WILLIAMSON COUNTY, TEXAS

CHANGE ORDER NUMBER: 6

Project: SE LOOP S1 P1

Change Order No. 6

**SE LOOP SEGMENT 1 PHASE 1
PLAN & PROFILE
FRONTAGE ROAD
EASTBOUND
STA. 1125+00-STA. 1130+50**

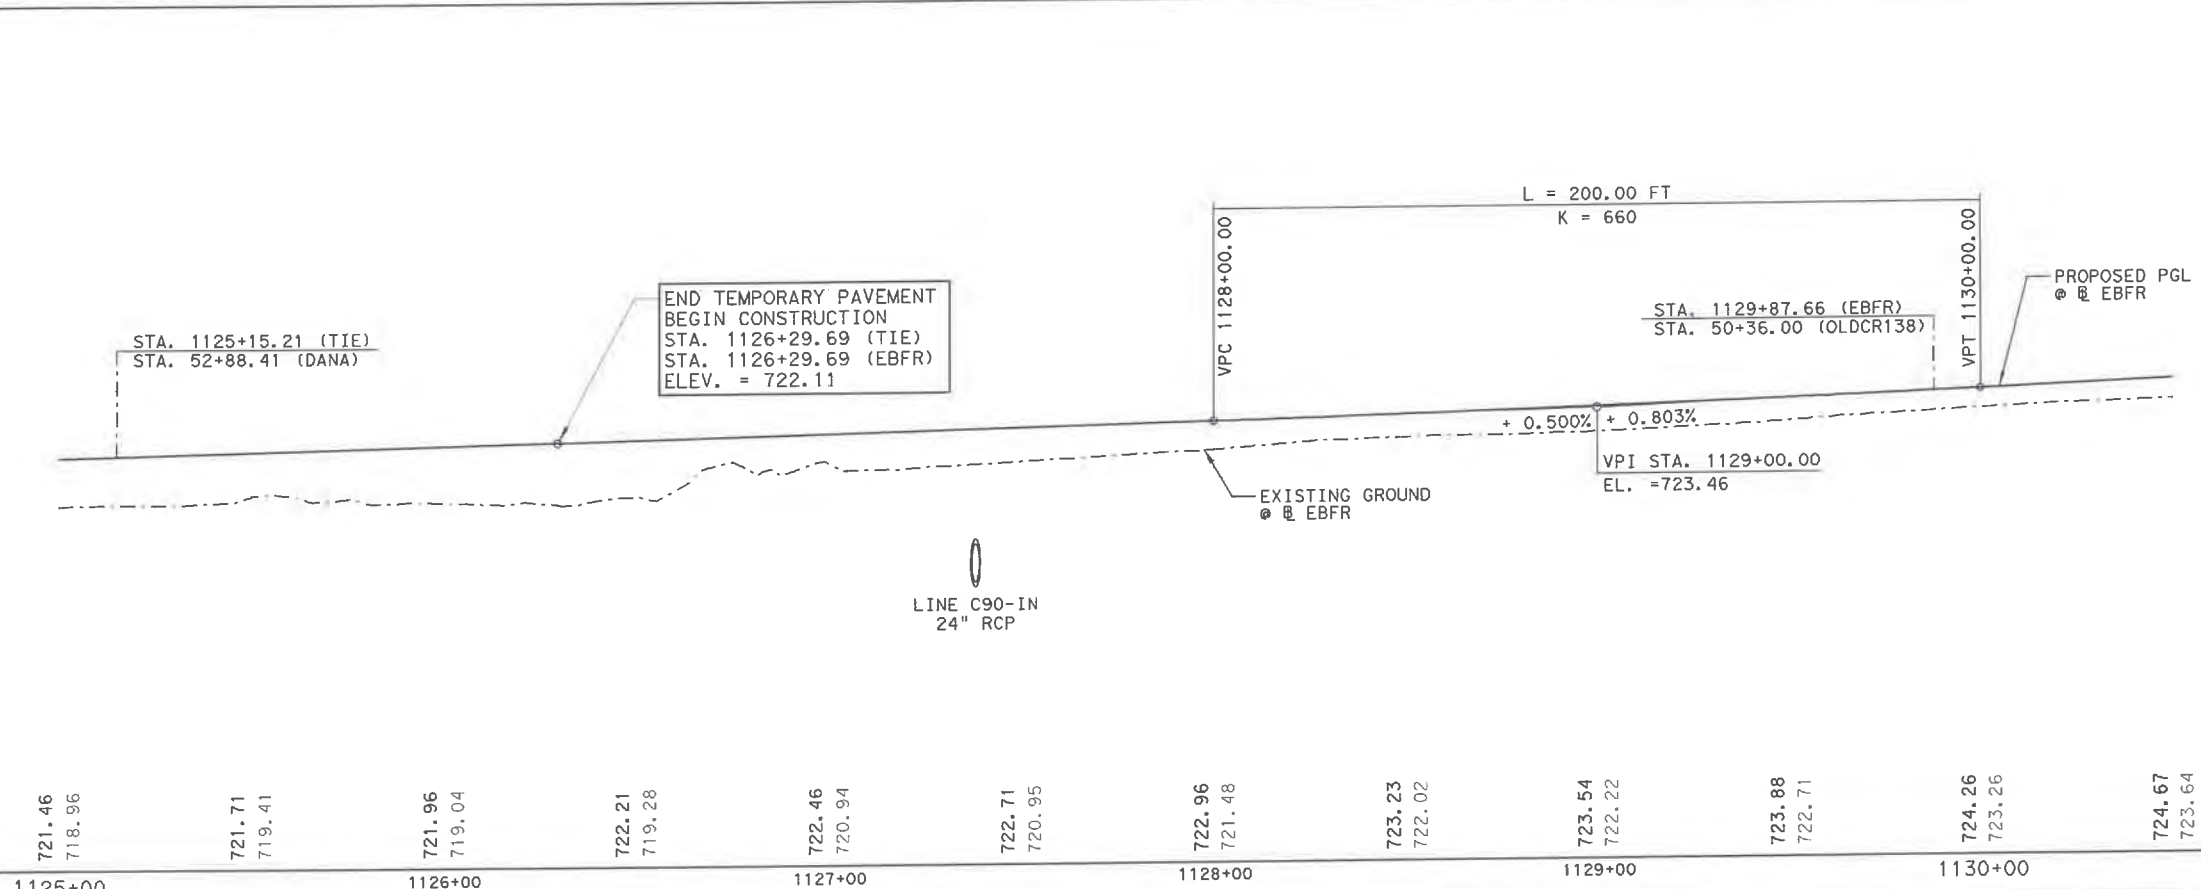
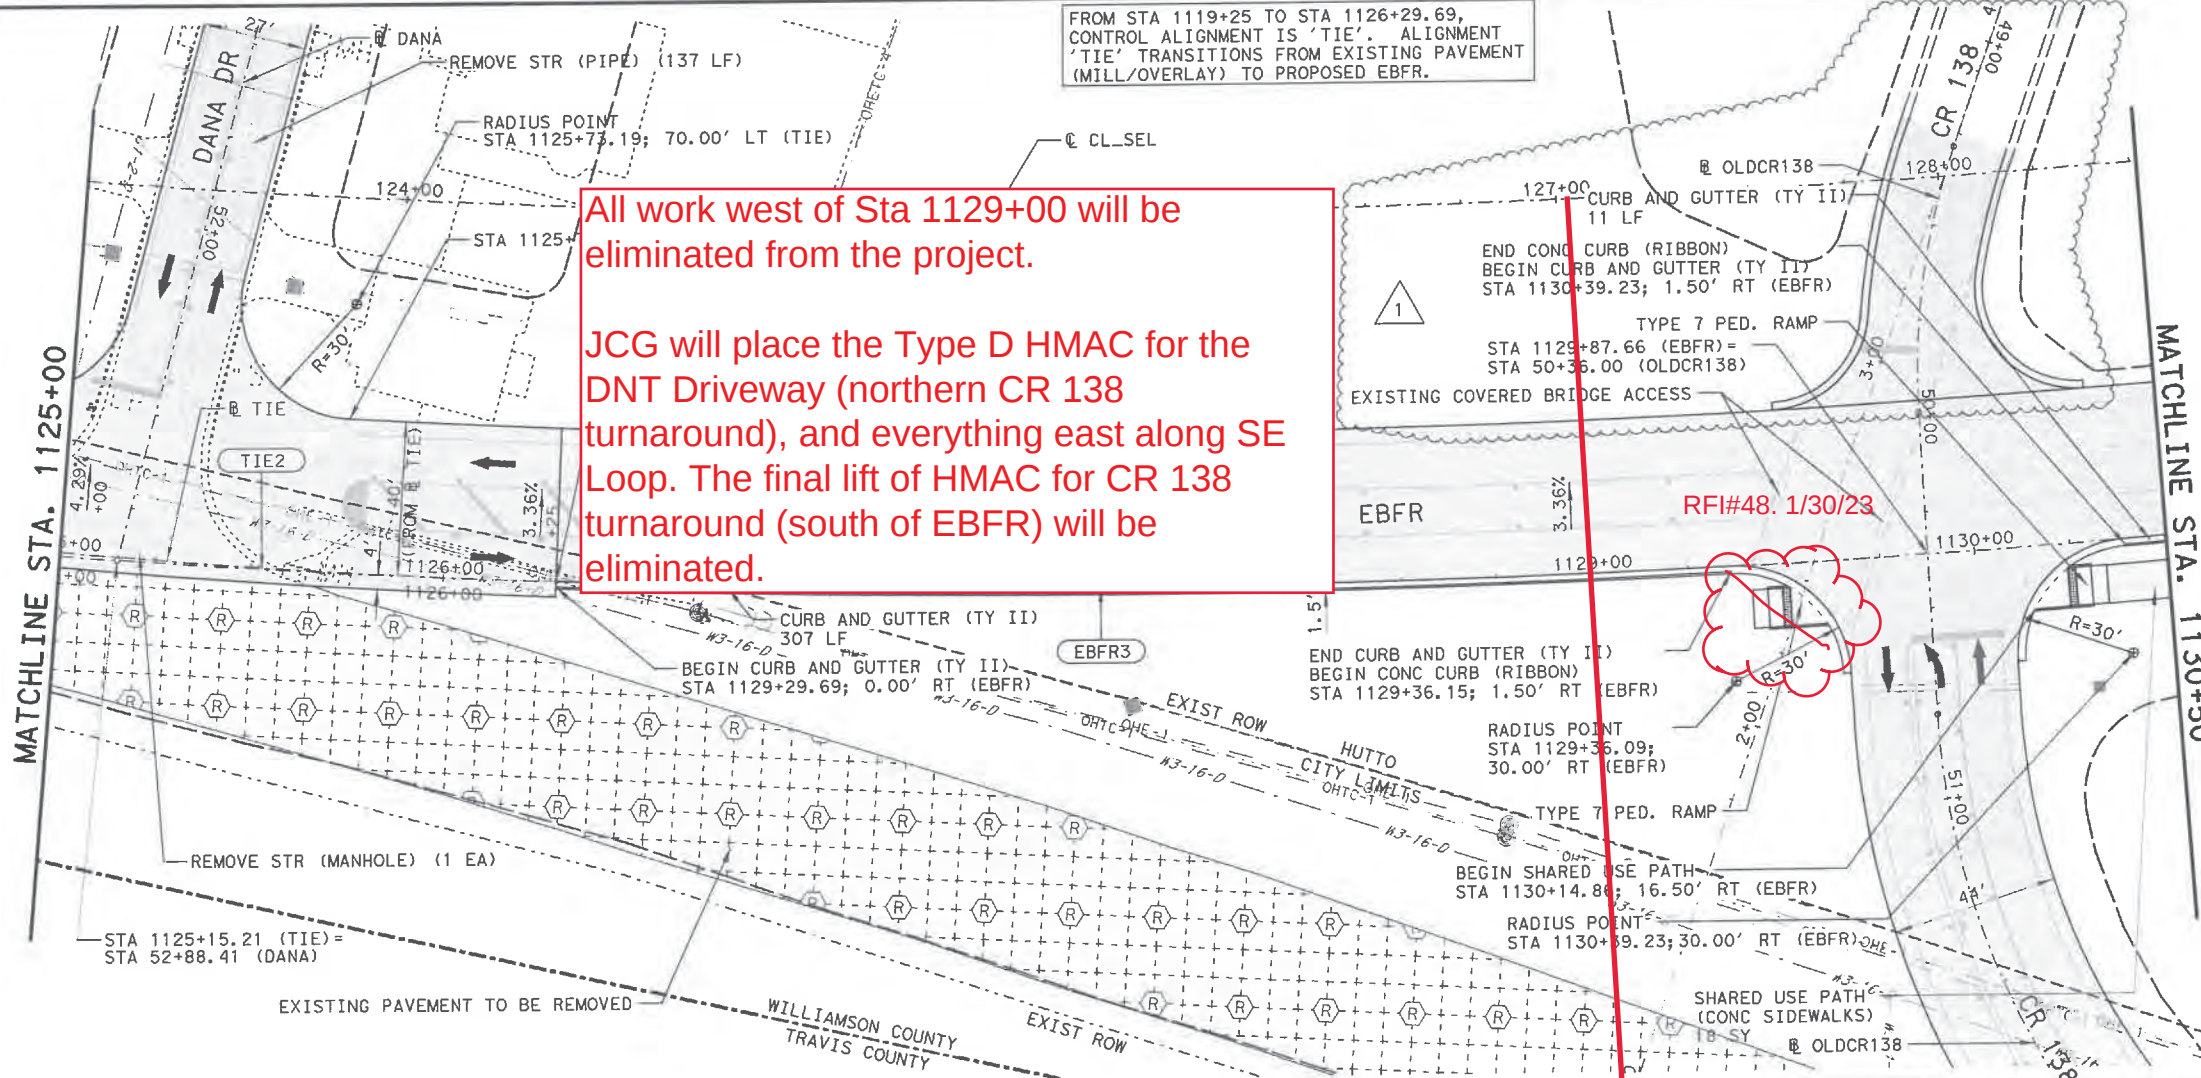
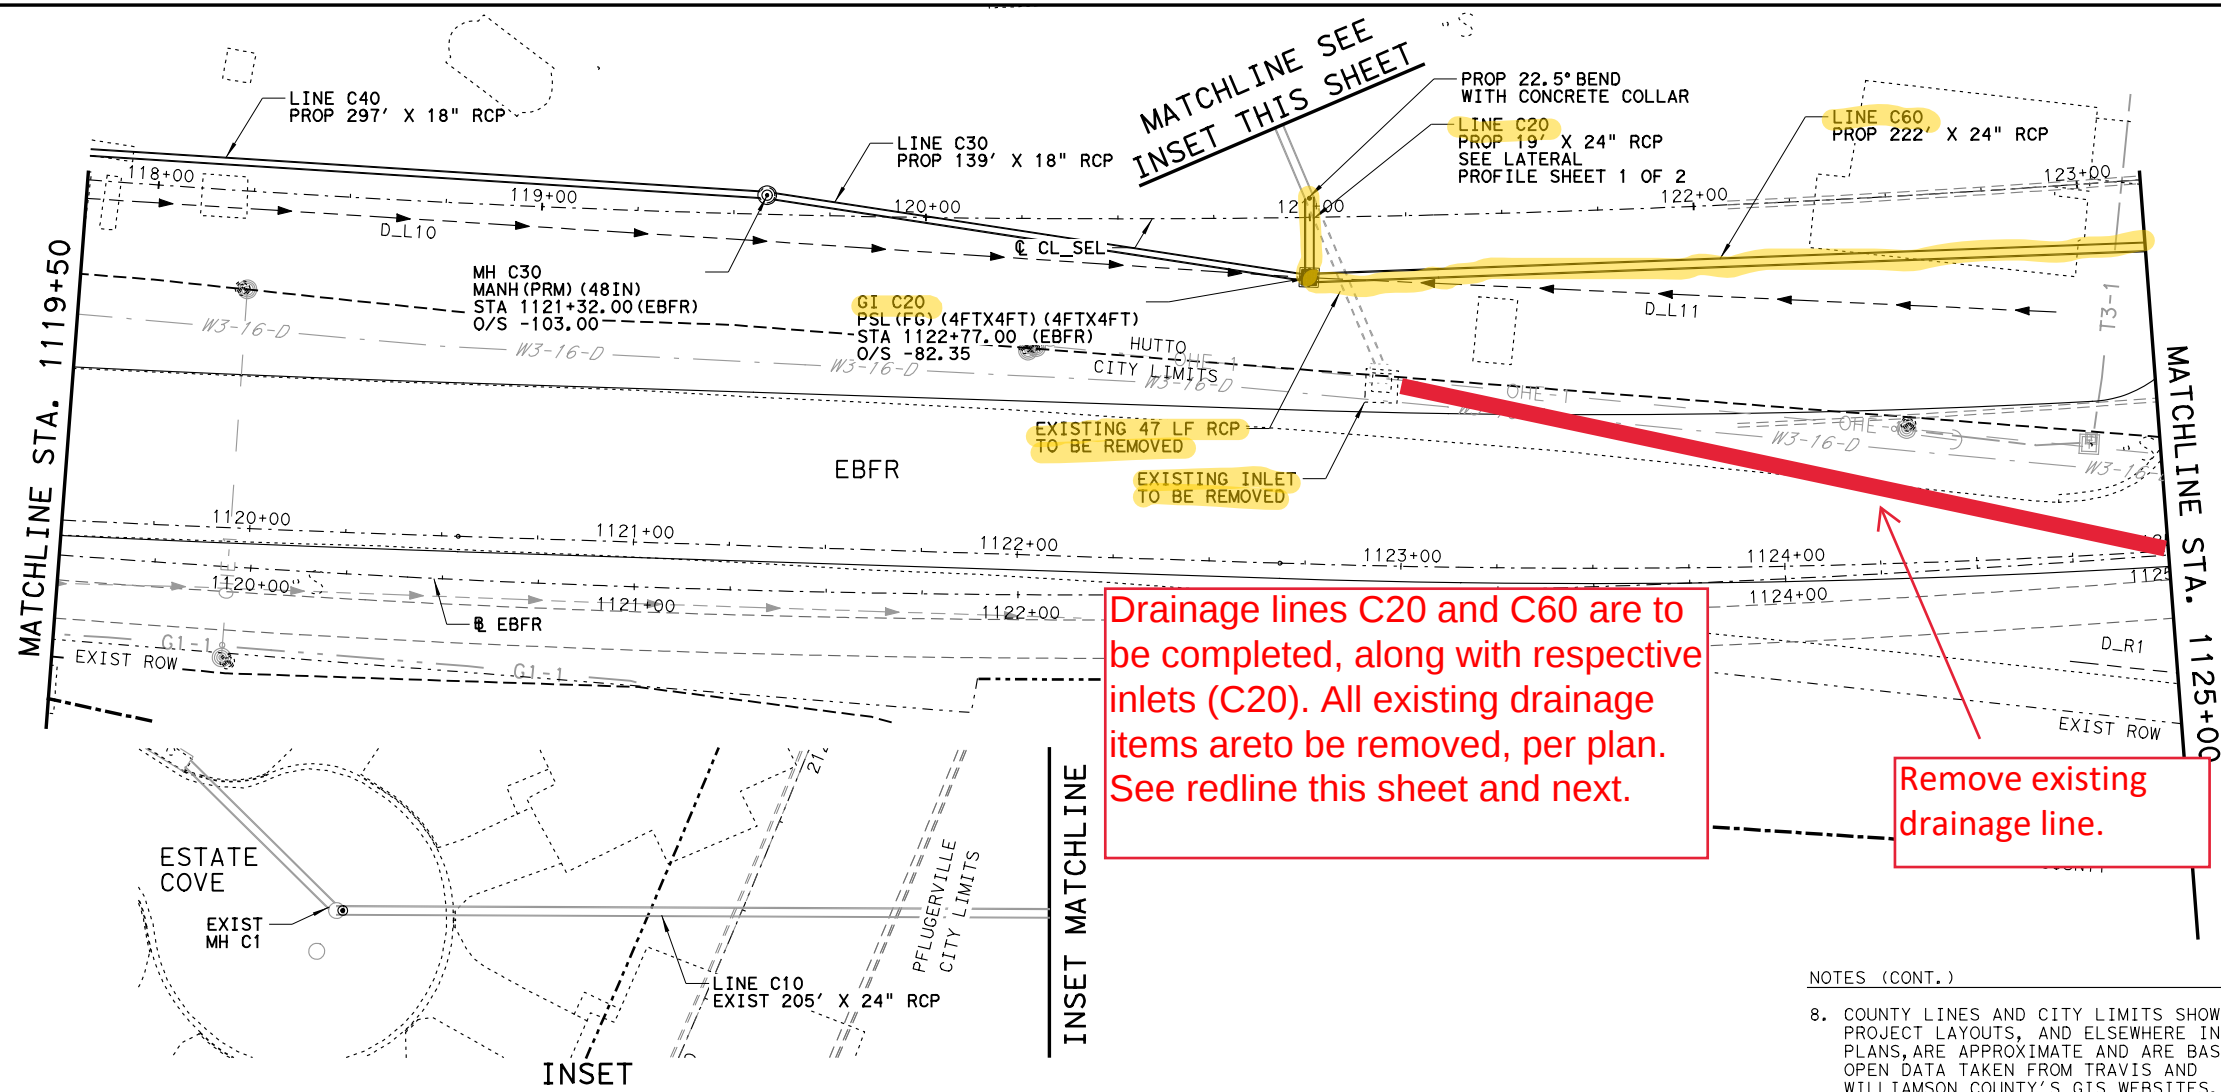
All work west of Sta 1129+00 will be
eliminated from the project.

JCG will place the Type D HMAC for the
DNT Driveway (northern CR 138
turnaround), and everything east along SE
Loop. The final lift of HMAC for CR 138
turnaround (south of EBFR) will be
eliminated.

**SE LOOP SEGMENT 1 PHASE 1
PLAN & PROFILE
STORM SEWER
EBFR
STA 1119+50 TO STA 1125+00**

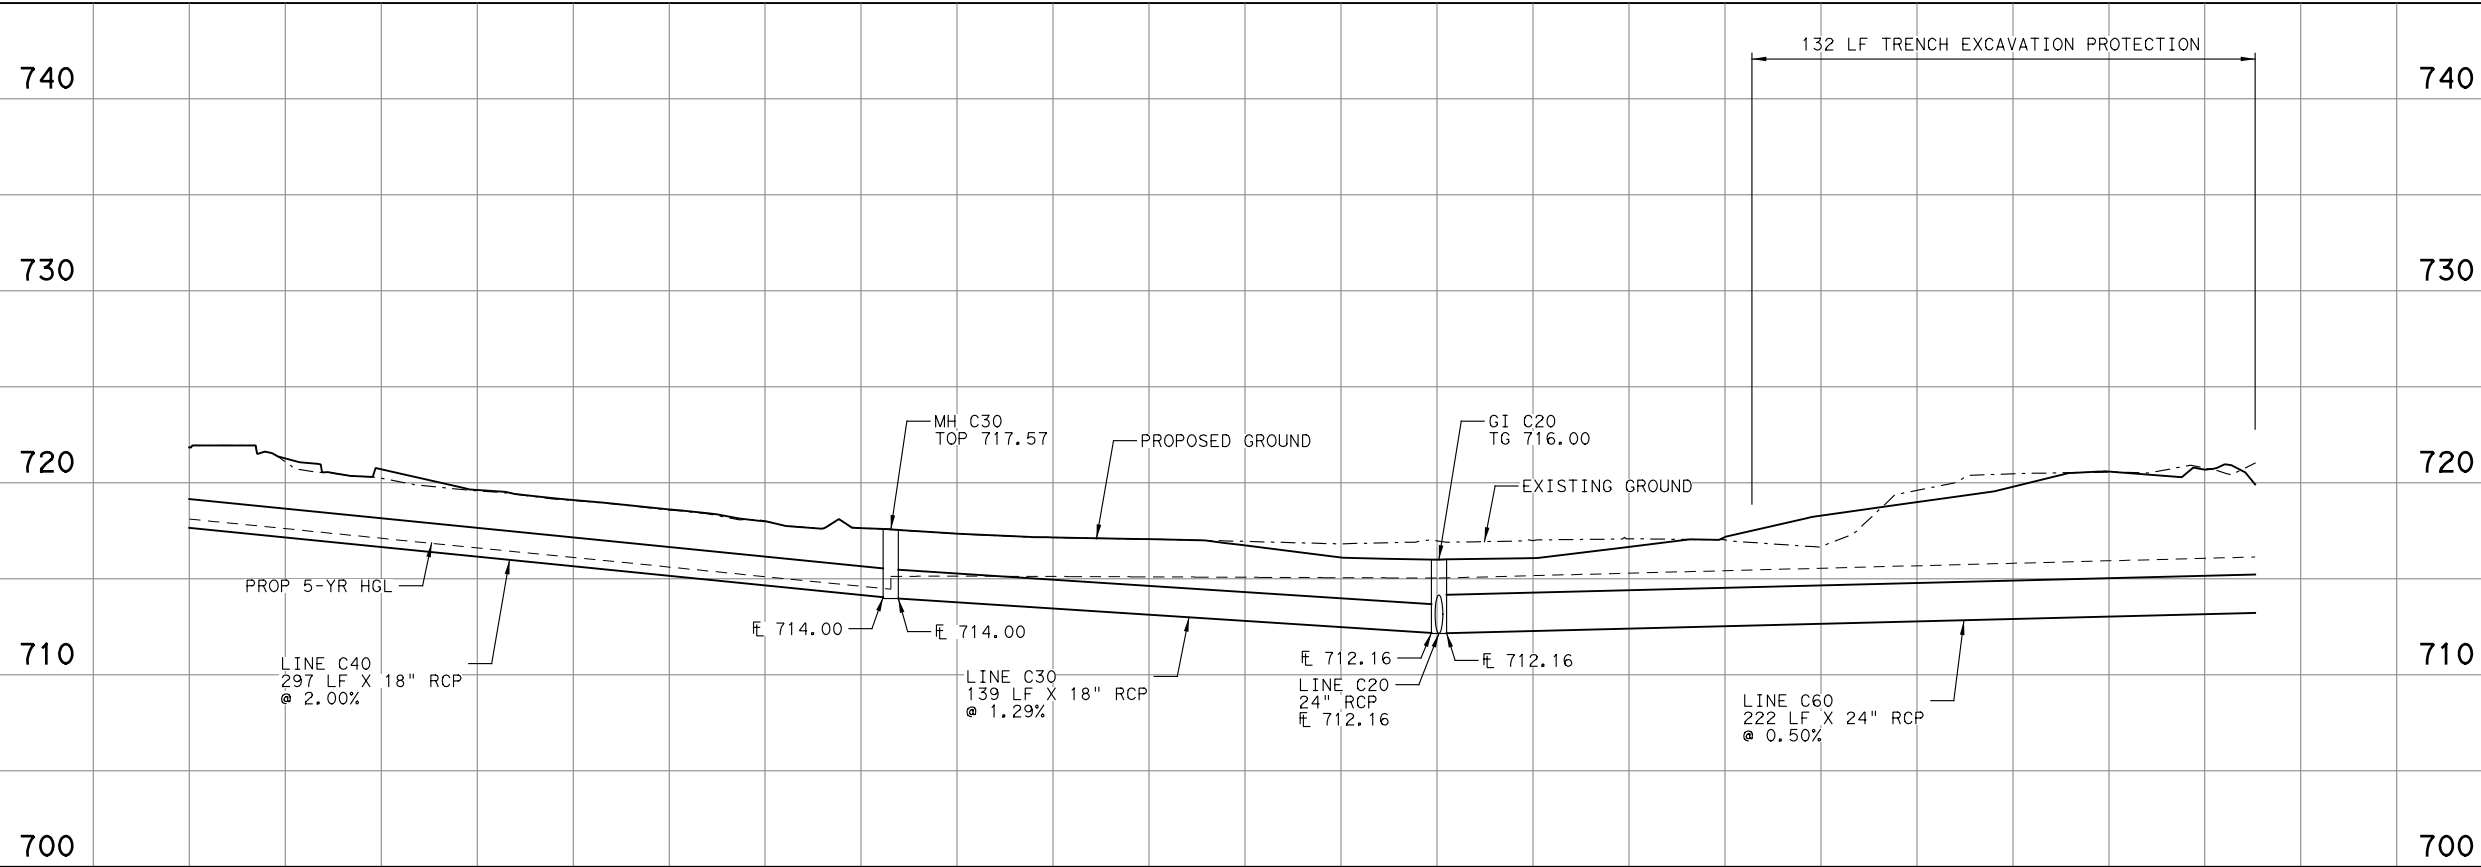
Drainage lines C20 and C60 are to be completed, along with respective inlets (C20). All existing drainage items are to be removed, per plan. See redline this sheet and next.

Remove existing drainage line.
